May 21, 2021

G-4638

**Subject: ADDENDUM LETTER 7
 PROPOSED DEVELOPMENT – LOWER BUILDING
 4270 EAST MERCER WAY
 MERCER ISLAND, WA**

PROJECT #: G-4638
DATE: 5-17-21
DRAWN: AG
CHECKED: WC
SCALE: ~ 1" = 20'
PLATE: 3-REV

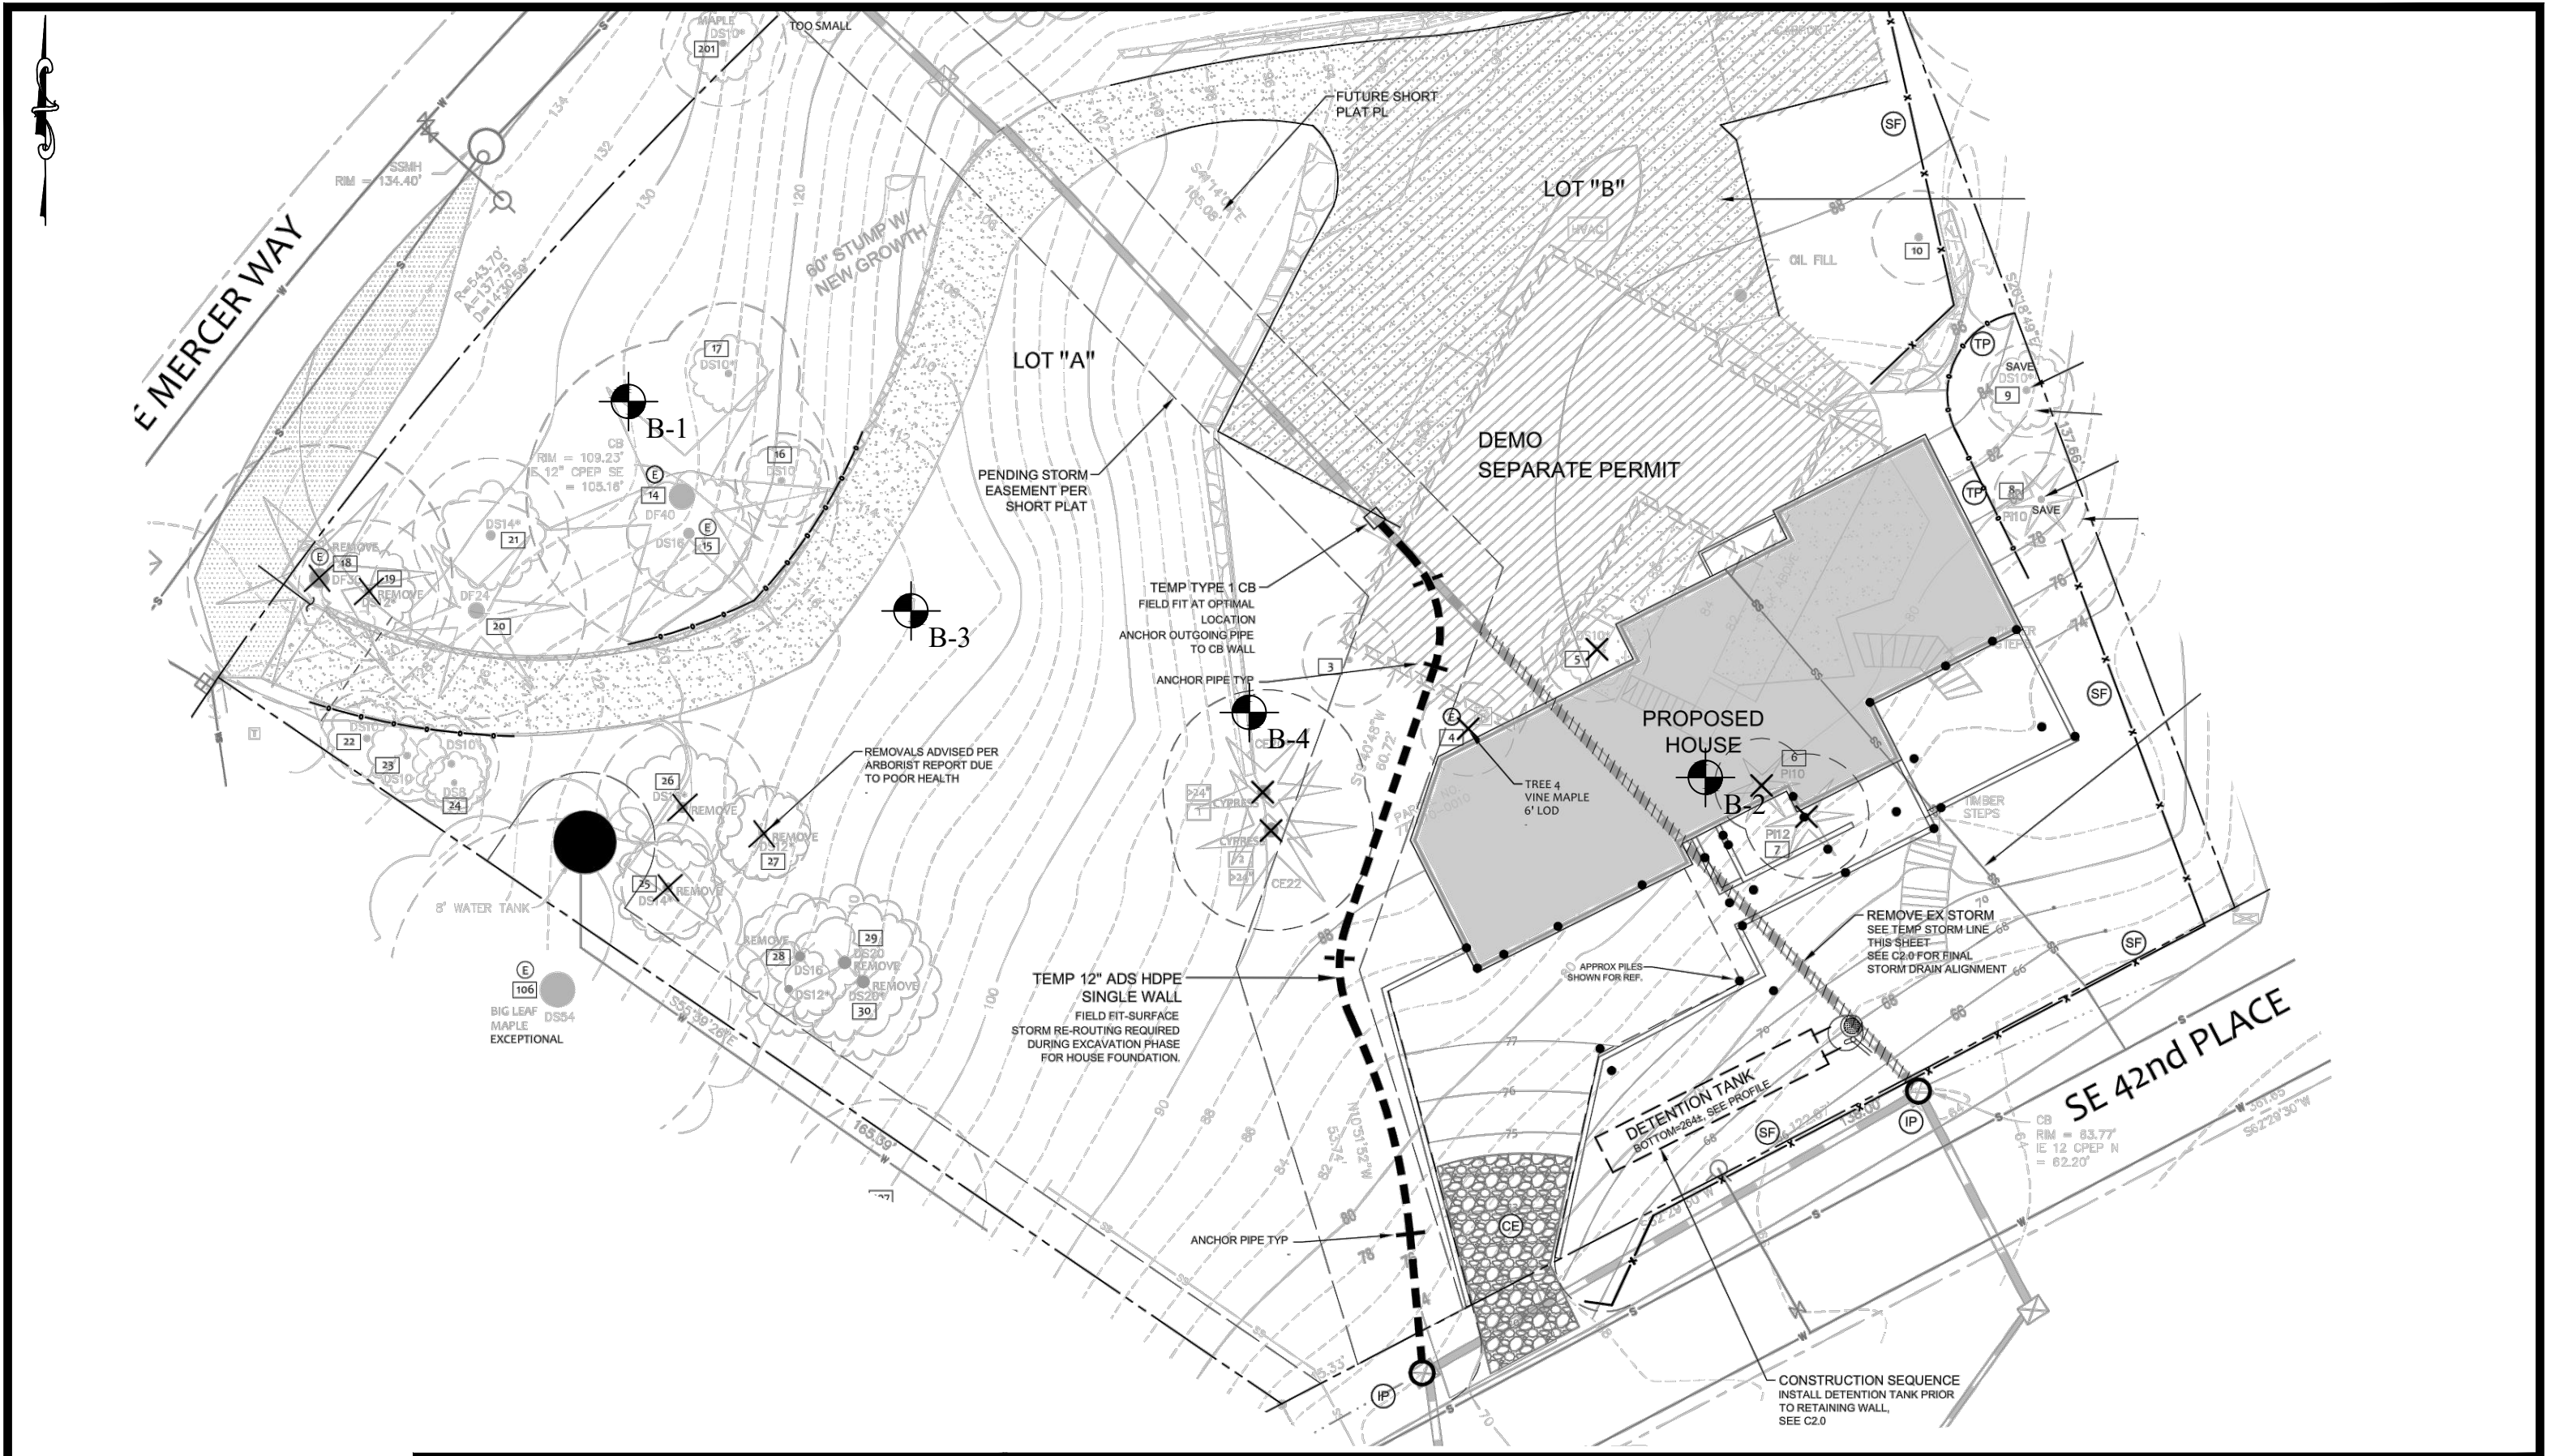
We have located our borings in relation to the property line corners on the CES Sheet C1.0 since it appears that this plan delineated the anticipated existing stormwater location and prepared the attached **Plate 3 – REV – Site Plan**. Following review of the site plan related to the stormwater re-routing we note that the existing stormwater trench (to be re-routed) is anticipated to be located in close proximity to our boring B-2. Further, on-site visual observation of the pipe direction and depth below grade indicates that the boring B-2 may have been drilled in an area where previous fills related to the existing stormwater piping are located. Soils observed at the boring B-2 (see attached **Appendix A**) consist of loose and very loose primarily very fine and fine sandy SILT overlying medium dense gray SILT at a depth of around 20-feet below ground surface.

Soils observed at boring locations B-1, B-3 and B-4 suggest that the competent medium dense to dense site soils are present at or around a depth of 5-feet below ground surface. Considering the apparent finding that B-2 may have been located in an area of previous fills related to the existing deep stormwater system it is our opinion that the boring B-2 is anomalous and may only be representative of soil conditions at the trench extents and depths from the earlier stormwater installation. We are not aware of installation records for this stormwater system, especially with regard to trench excavation slopes or construction methods.

Alternatively, it is our opinion that the building may be supported with pipe (pin) piles at the apparent former trench area and any area disturbed/non-compacted and not currently approved related to the recent stormwater piping removal. At locations where it can be confirmed that the soils at the foundation subgrade level consist of the native undisturbed medium dense to dense site soils and which are not fills related to the former trench or unapproved fills related to the recent stormwater piping removal the building may be supported on typical shallow spread footings which bear on the competent medium dense to dense site soils or on compacted structural fill placed on top of these competent soils. We anticipate that it may be somewhat difficult to determine the subgrades which have been impacted by the trench or the recent pipe removal due to the fact that the apparent trench backfill consists of native soils. Therefore, the owner may consider re-designing the entire foundation to be supported by pin piles. Thereby eliminating the need to determine the transition points from pin piles to spread footing foundations.
